SL-410 Replacement Scale

****SL410 scale has been discontinued****

Old
Scale SL410
Replacement

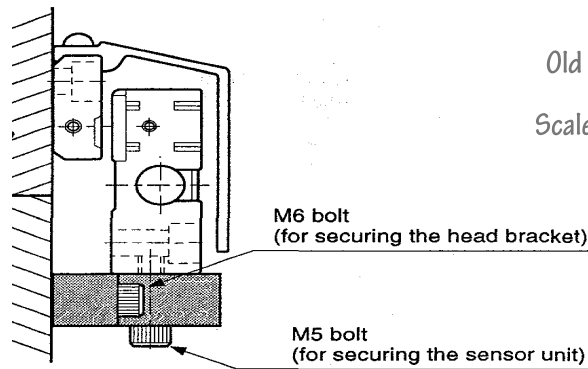
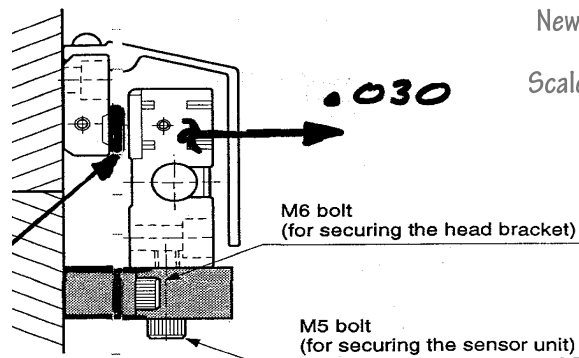
We have a new magnetic media that can be applied over the existing damaged scale. It is applied with double sided tape (similar to SL-130 product)

Only change needed to be made is to reader head, it will need to be spaced out an additional .060

New
.030
Scale is
added

- Green LED light should stay on as machine moves.
- Move reader head back so a .014 gap is between the new scale and the reader head
